**RE: Enterprise Class III Landfill, Pasco County [WACS facility #87895]
Construction Permit Renewal Application, Pending Permit #177982-019-SC/T3
Operation Permit Renewal Application, Pending Permit #177982-020-SO/T3
Response to Environmental Monitoring Review Comments**

ATTACHMENT 1
RESPONSES TO COMMENTS

Enterprise Class III Landfill Water Quality Monitoring Plan Evaluation

ATTACHMENT 3
REVISED GROUNDWATER MONITORING PLAN

FIGURE 2 - Revised

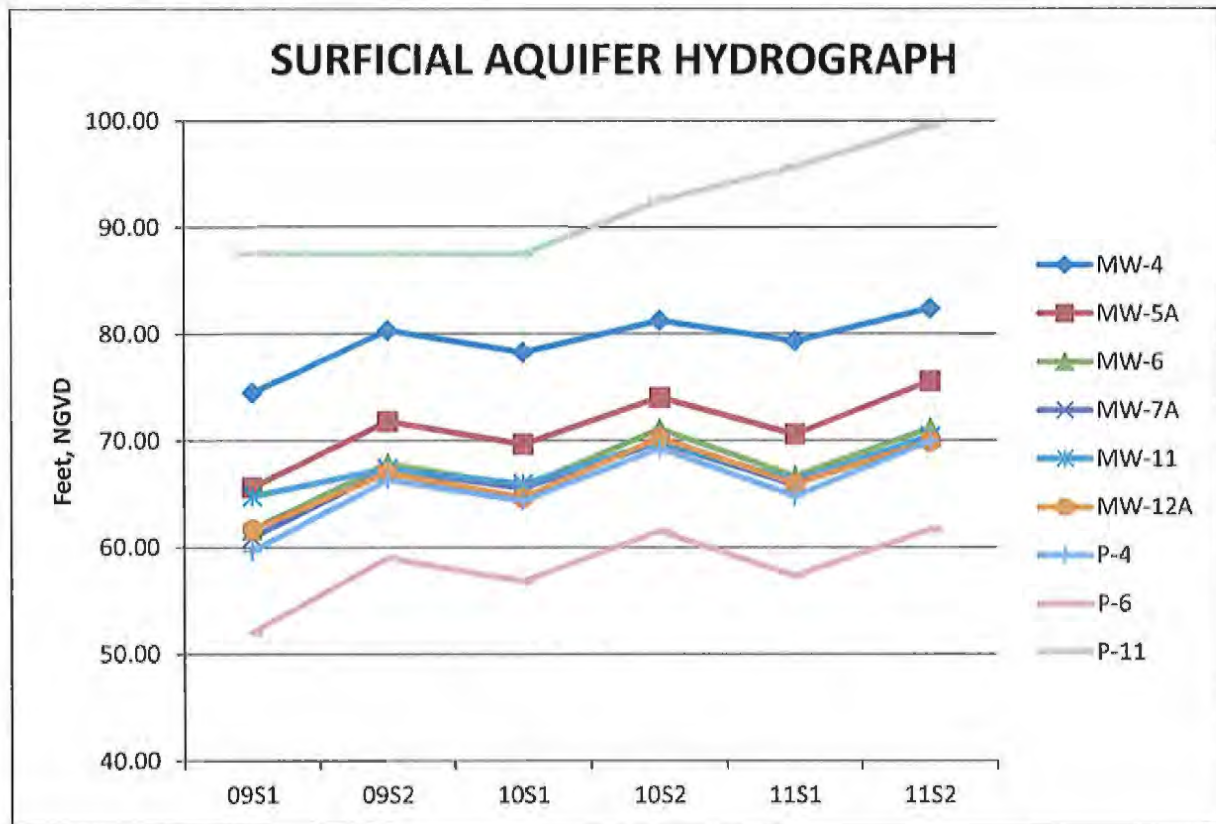
c. The response letter indicated that the ground water elevation reported for well MW-12A for the September 2011 sampling event was 69.91 feet NGVD, and referred to Table 2 of the revised 2012 WQMPE document that was amended to reflect this value. Please submit revisions to Figure 2 to indicate a ground water elevation of 69.91 feet NGVD was measured at well MW-12A for the September 2011 sampling event.

The response letter also indicated that Section III of the revised 2012 WQMPE document included a new recommendation that well MW-12A be re-developed and sampled, or that well MW-12A be replaced if re-development is not effective. It is noted that the report for the most recent sampling event conducted at the facility during September 2012 (received January 10, 2013) indicated more than an 8-foot rise in water levels compared with the previous sampling event conducted during March 2012. However, this report also indicated that well MW-12A was not able to be sampled during September 2012 as it pumped dry during the lowest achievable flow rate. Please implement the proposed recommendation to investigate the ability to sample existing well MW-12A and submit additional revisions to Section III regarding the need to install a replacement. In the event that a replacement well is proposed, please include the rationale for construction details of the replacement well (including unique identification number) in Section III of the revised 2012 WQMPE document.

Figure 2 of the WQMPE document has been revised to indicate a groundwater elevation of 69.91 feet NGVD was measured at well MW-12A for the September 2011 sampling event.

A groundwater sample was not able to be collected from well MW-12A during the September 2012 sampling event despite the presence of a significant water column in the well. However, since MW-12A is proposed to be utilized as a "water level only" well (see Table 1 and Figure 1 of the GWMP), installing a replacement monitoring well does not appear to be warranted.

FIGURE 3

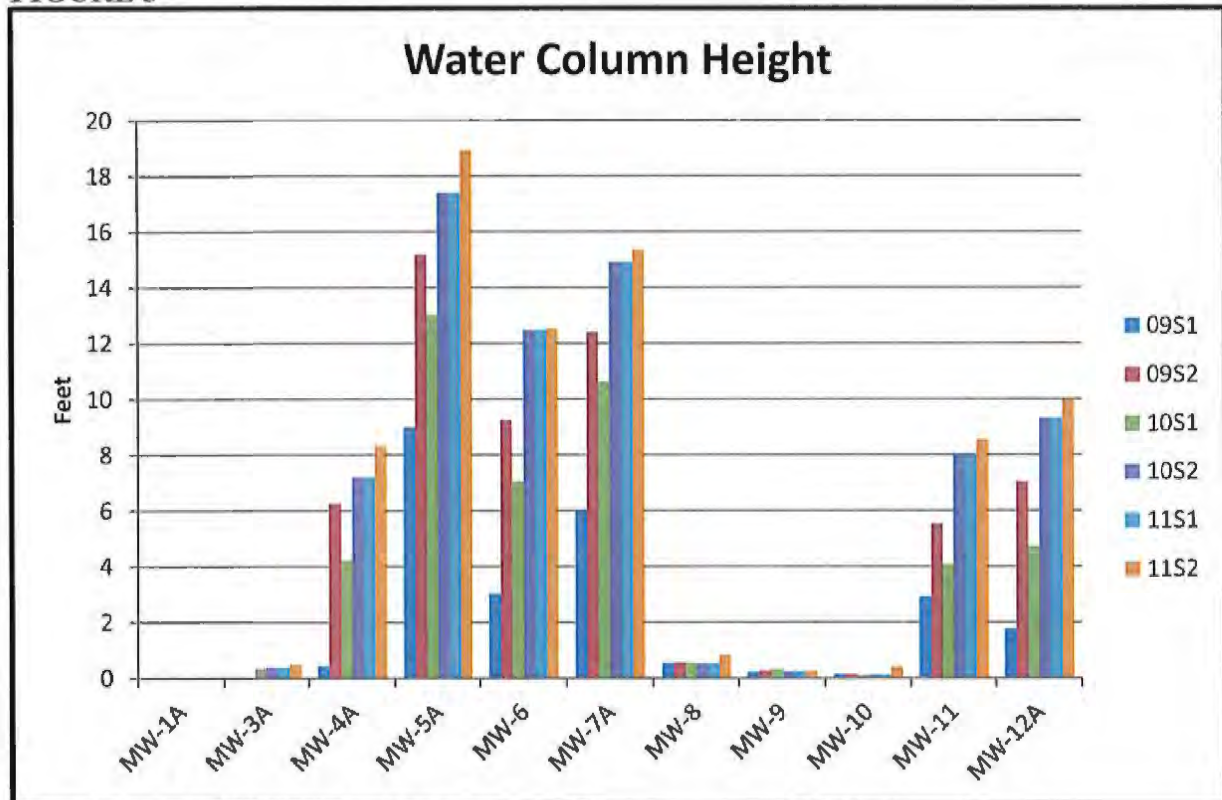
b. The response letter referred to Tables 2, 3 and 4 and to Figure 3 of the revised 2012 WQMPE document that were annotated to indicate that water levels in wells MW-3A, MW-8, MW-9 and MW-10 represented water retained in the well sumps. **No additional information is requested.**

FIGURE 4 (Revised)

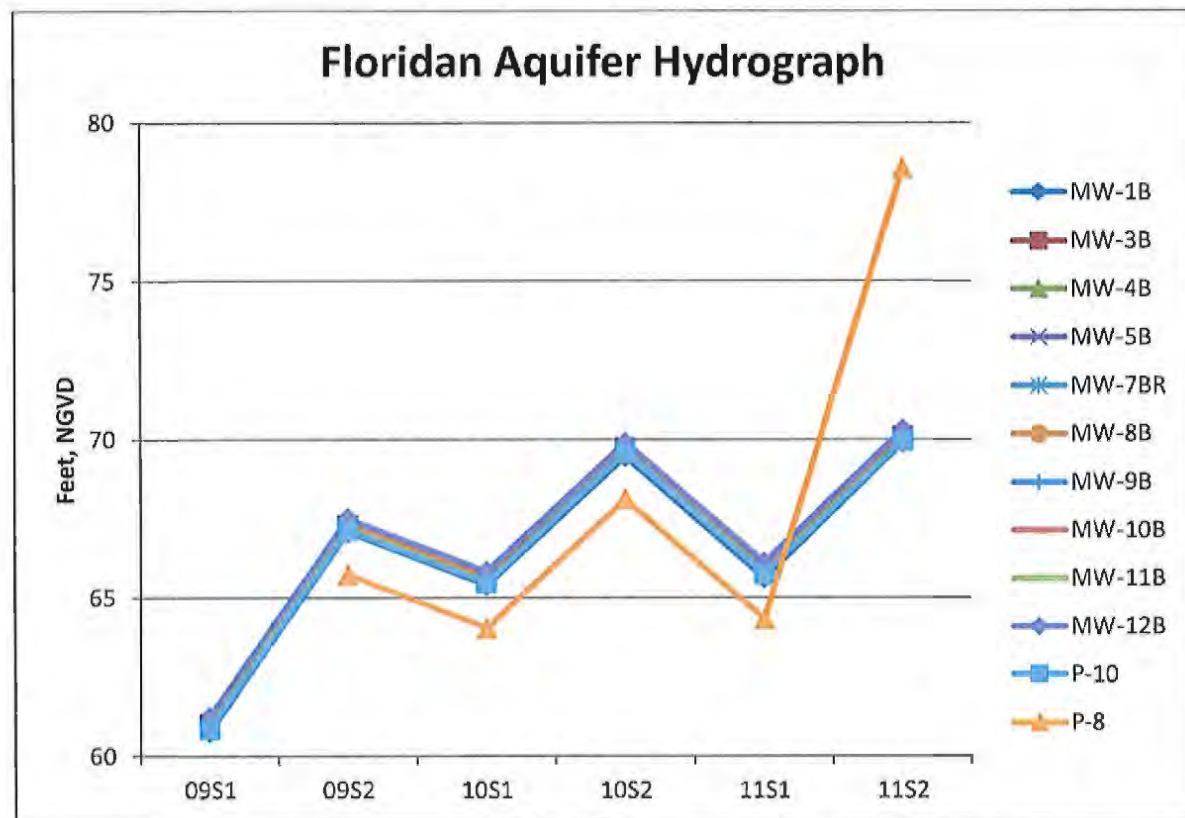
f. The response letter indicated well MW-8B was re-surveyed during November 2012, and the new top of casing elevation was used to revise Table 5 and Figure 4 of the revised 2012 WQMPE document. Please submit a copy of the new survey information prepared for well MW-8B.

FIGURE 6

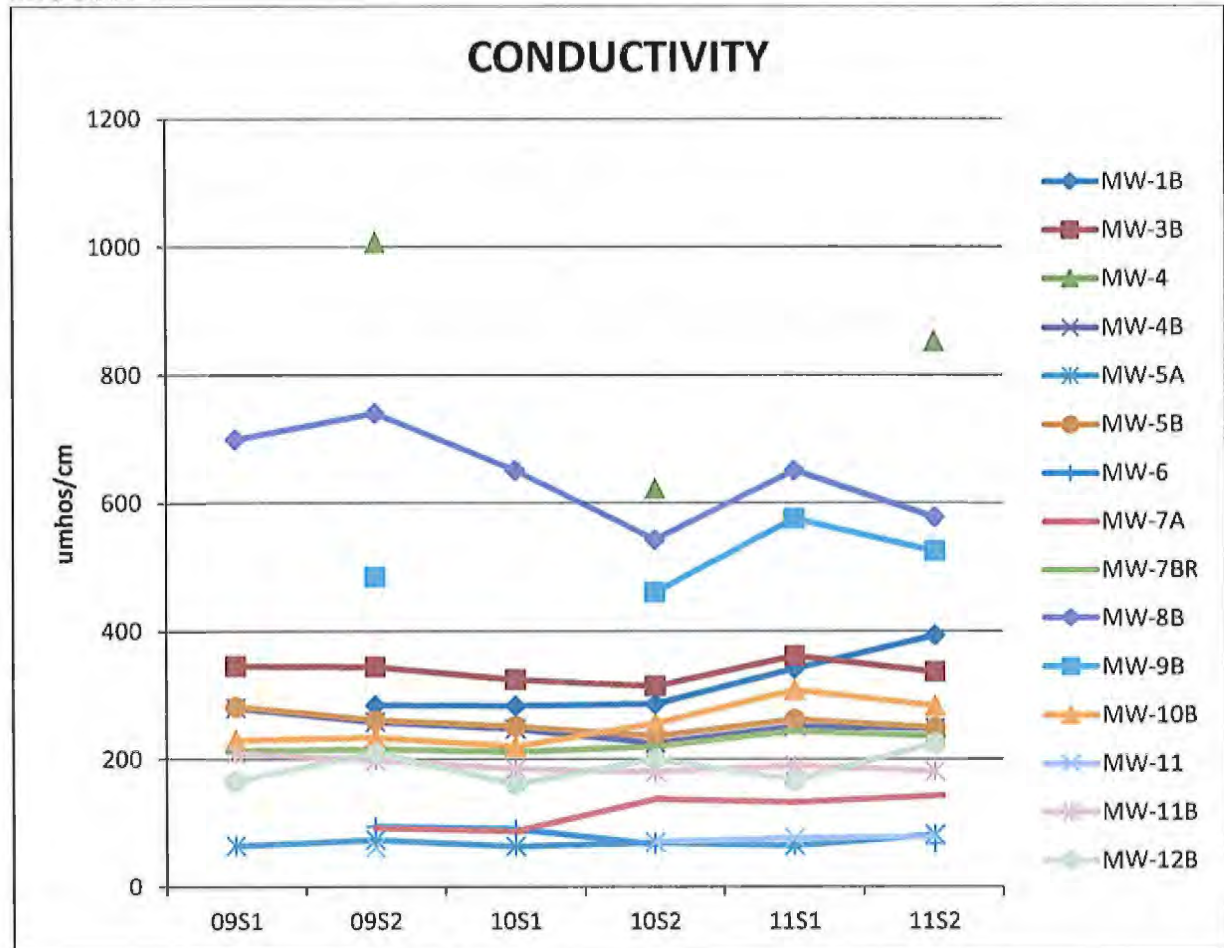
- 4) The response letter indicated Figure 6 (conductivity values reported during the review period) was revised to be consistent with the conductivity values presented in Appendix G. **No additional information is requested.**

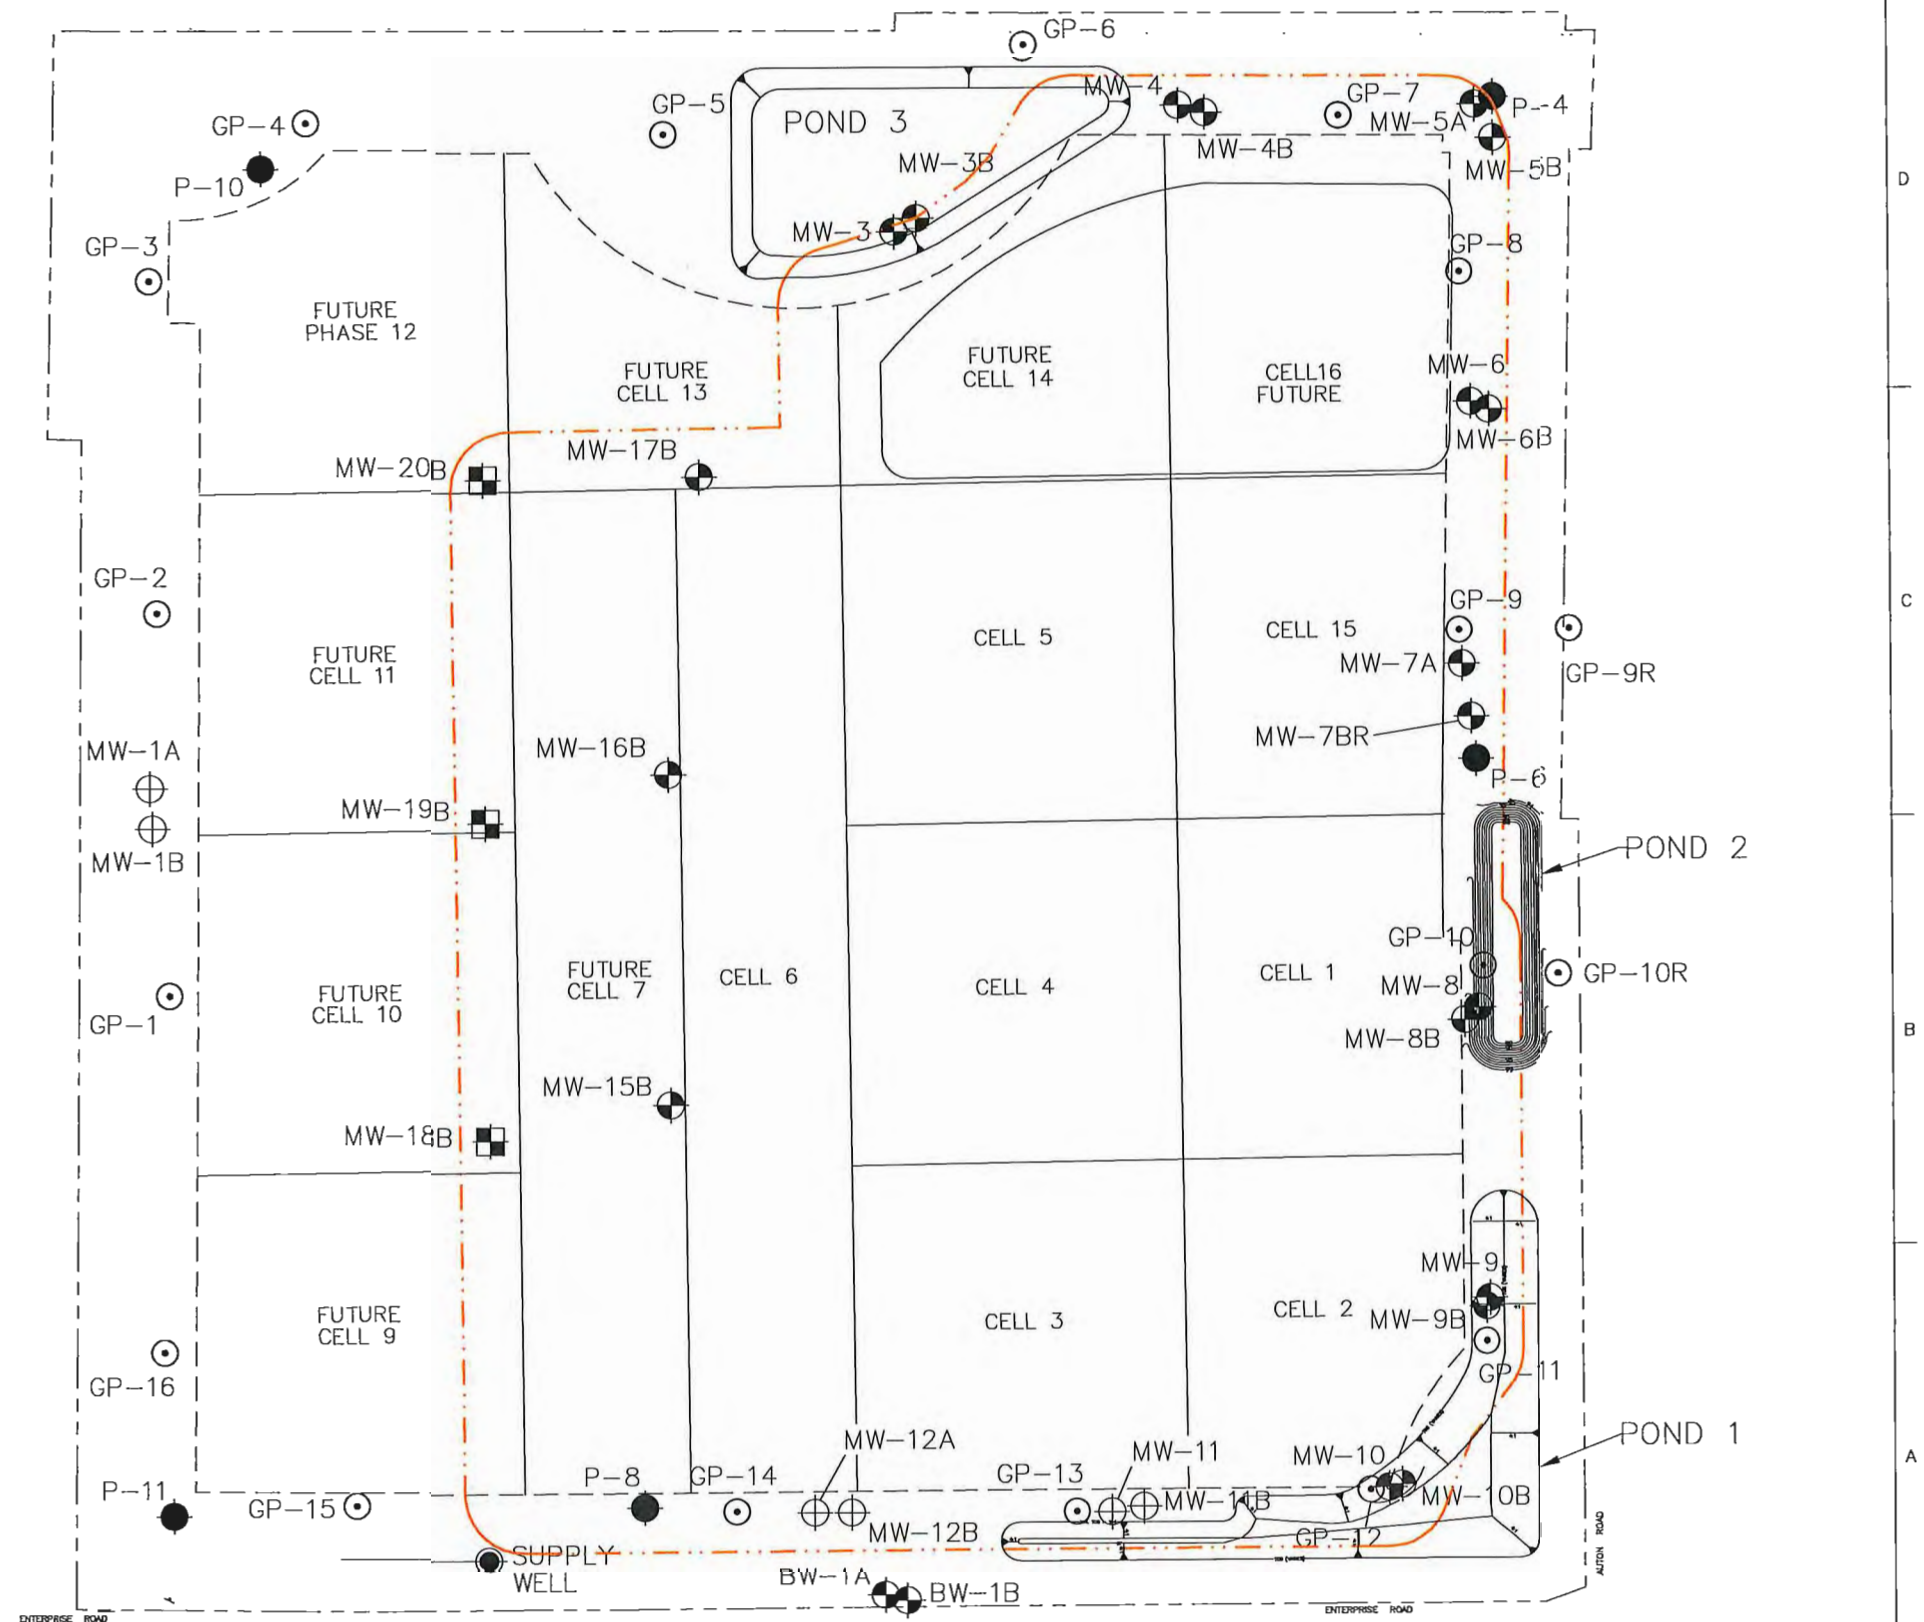
b. The response letter indicated that Table 1 and Figure 1 of the revised 2012 GWMP document were amended to reflect the monitoring network associated with disposal up to and including Cell 7. Please submit additional revisions to Figure 1 as follows:

- Change the symbols for wells MW-1A and MW-1B to indicate they will be used as "water level only well locations;" and,*
- Delete the well MW-13 location.*

The response letter indicated Section 1.e., of the revised 2012 GWMP document had been amended to describe semi-annual surface water monitoring at Pond 1 (southeast of Cell 2) and at Pond 2 (east of Cell 1), and that Figure 1 had been revised to show the associated surface water sampling locations (SW-1 and SW-2, respectively). Please submit additional revisions to Section 1.e., and/or Figure 1 to identify where water discharging from Pond 1 and Pond 2 would leave the property.

Figure 1 of the GWMP has been revised to change the symbols for wells MW-1A and MW-1B to "water level only" locations and to remove the well MW-13 location.

Ponds 1 and 2 do not discharge off-property. Any potential discharges from Ponds 1 and 2 will flow to the Temporary Pond identified in Figure 1 as Pond 3. Therefore, Section 1.e and Figure 1 of the GWMP have been revised to remove surface water sampling locations SW-1 and SW-2. In the event that groundwater impacts are observed in future compliance monitoring, a surface water sample will be collected from Pond 3.

FIGURE 2

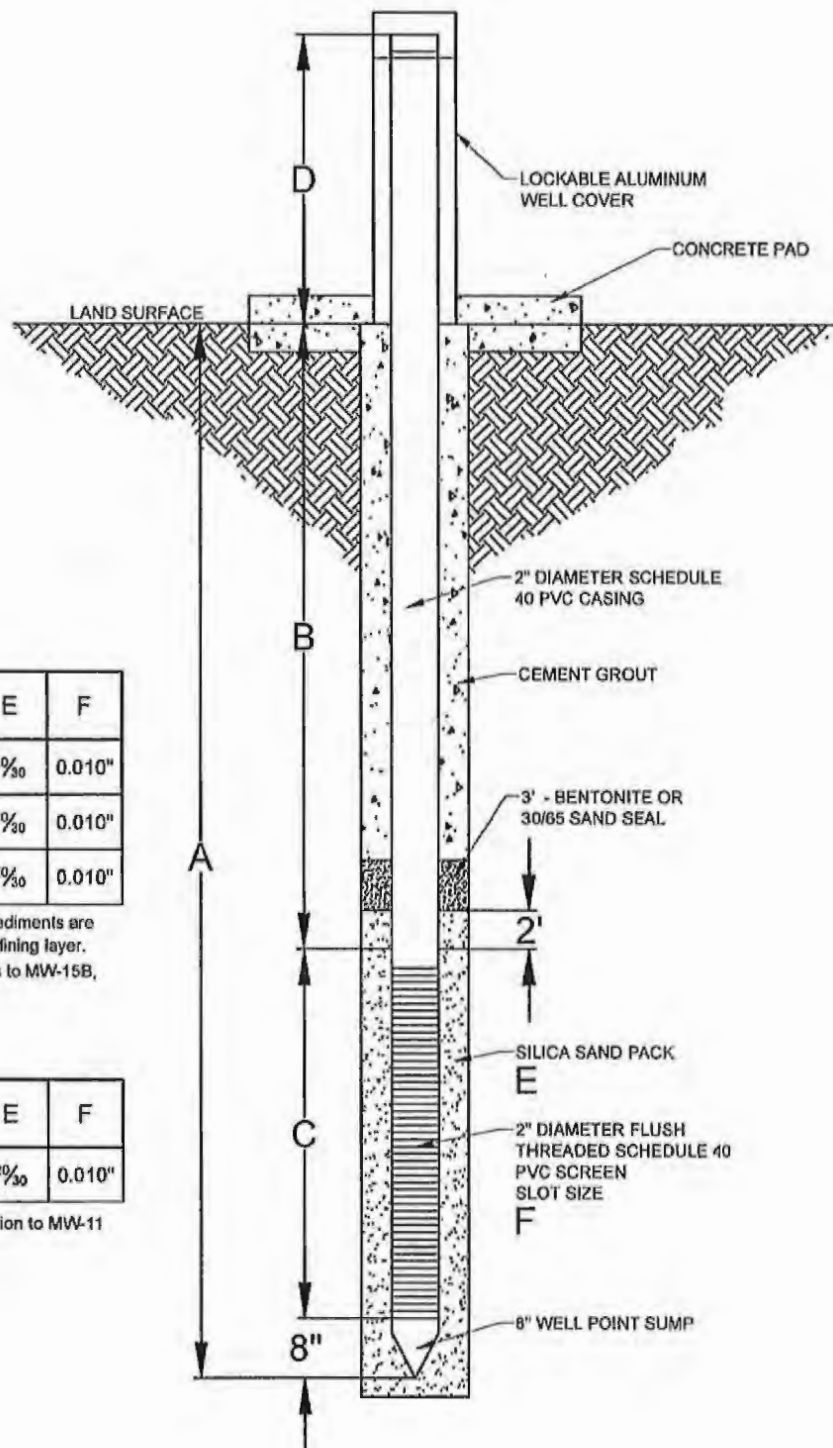
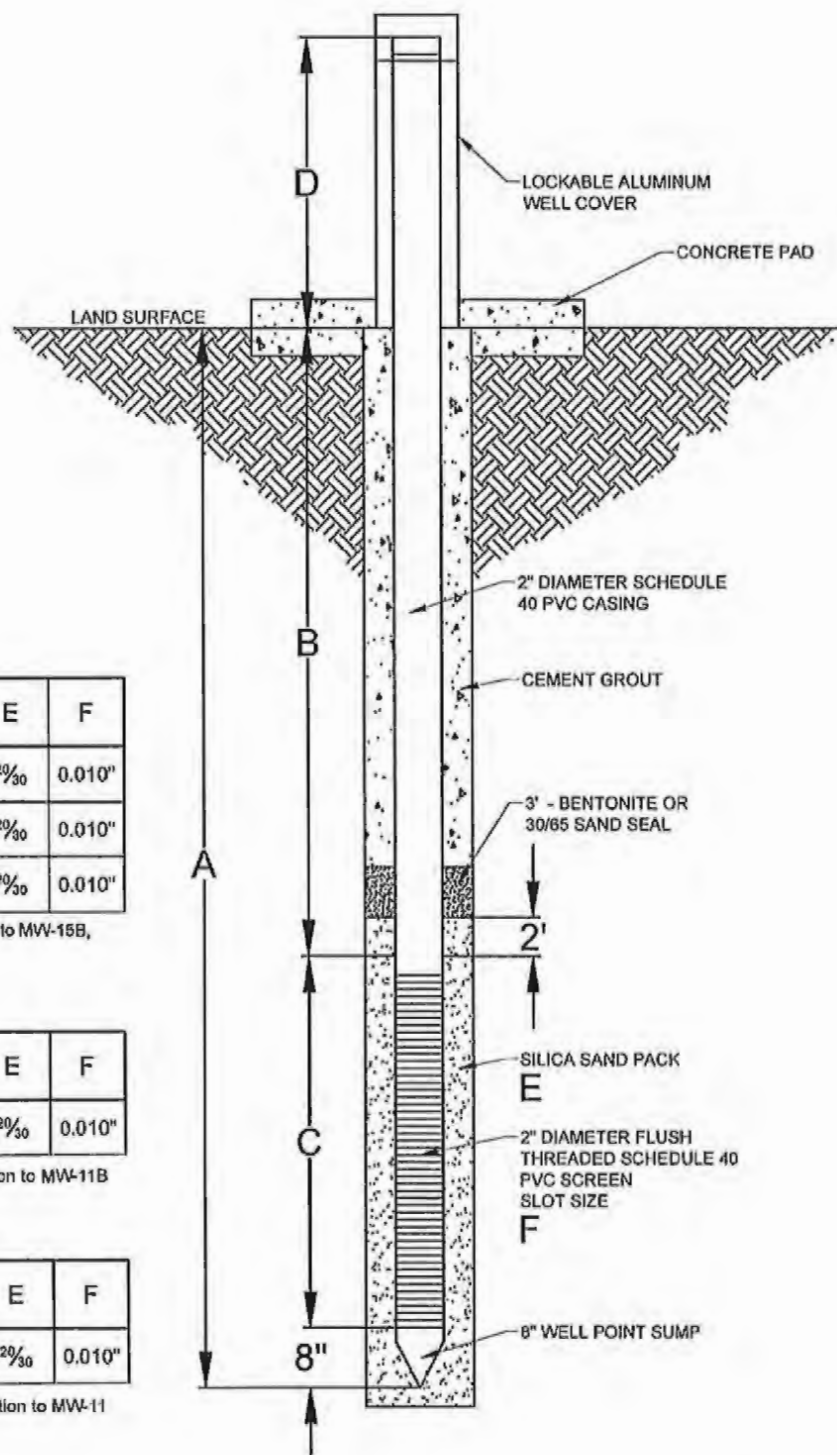
a. The response letter indicated that Section 1.d., Figure 2, and Figure 3 of the revised 2012 GWMP document had been amended to provide the construction details for proposed wells MW-18A/MW-18B, MW-19A/MW-19B, and MW-20A/MW-20B. Please submit additional revisions to Section 1.d., Figure 2 and Figure 3 to provide the justification of construction details for proposed wells BW-1A, BW-1B and MW-6B.

Section 1.d and Figures 2 and 3 of the GWMP have been revised to include construction details for proposed wells BW-1A, BW-1B and MW-6B.
